PSB-2008-028-B	Date: February 20, 2009
Title	SERVICE ACTION; ZD326 & ZD331, Ground Wire Relocation
Group Code	EL05 – Wiring Harness
Product Line	Z - Tractor
Model Number (s)	ZD326S/P & ZD331P/LP

SERVICE ACTION

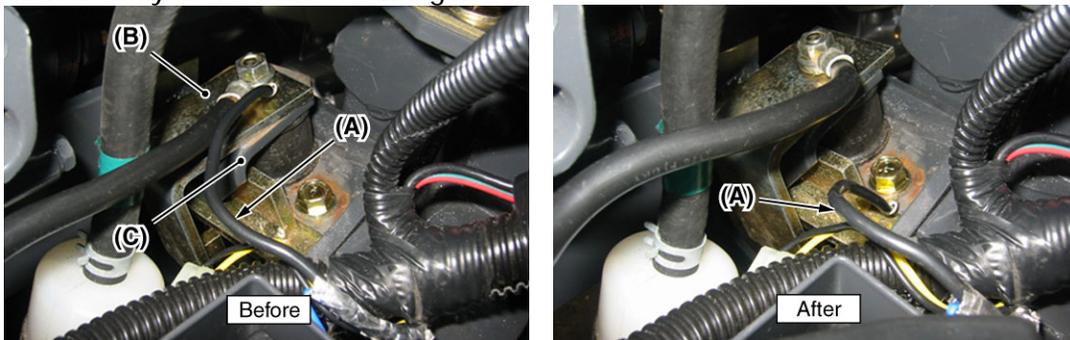
Kubota has determined that there may be poor or inadequate contact between the harness ground wire and the negative battery cable at the engine mount isolator (see "Before" photo below). This may result in poor or insufficient starting performance.

Please relocate the harness ground wire eye directly to the frame as per the instructions of this bulletin (see "After" photo below). Check/clean all ground contact points to ensure adequate grounding. Replace wire harness only in the case of damage.

Fig. 2

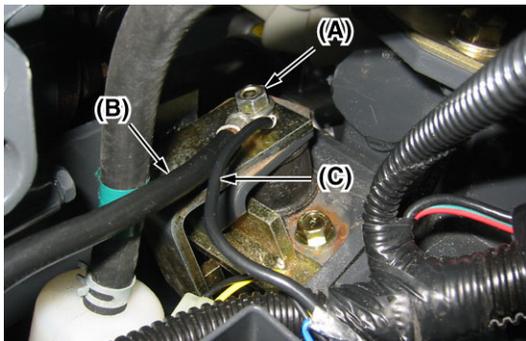
2. (Right Hand Side Only)
Remove the nut (A), negative battery cable (B), harness ground wire (C), washer (D), and engine stopper (E). Fig. 2 & 3

Fig. 4

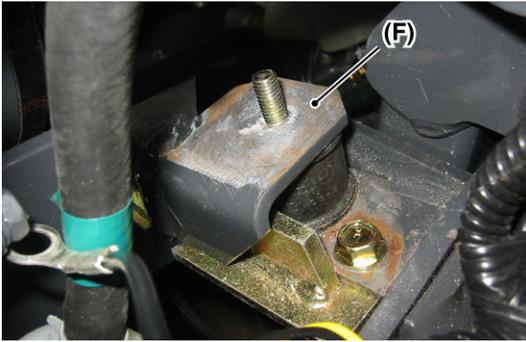
3. Inspect the engine stopper (E) and engine support (F) for corrosion, paint, and burs. If any are found, sand down the problematic areas. Fig. 4 & 5 **IMPORTANT: Area needs to be clean and free of debris to ensure proper contact.**

Fig. 9

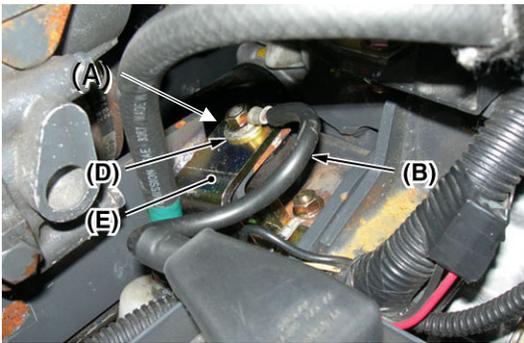
8. Place the negative battery cable (B) to the engine stopper (E) and washer (D) with nut (A). Fig. 9
IMPORTANT: Slide the engine stopper (E) to its most forward position while tightening the nut (A)
 Torque the nut to 13-15 ft-lbs (18-20 N-m) Fig. 9

Fig. 10

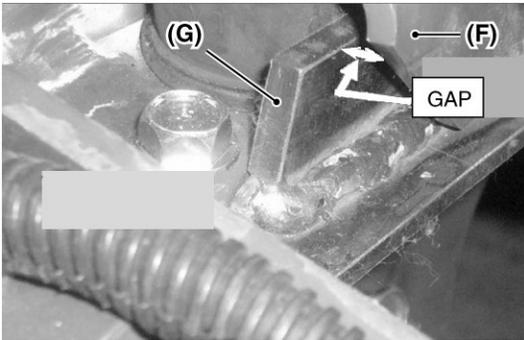
9. Verify correct GAP between stopper (G) and engine support (F). GAP tolerance is 1-4 mm (0.04-0.1 in) Fig. 10
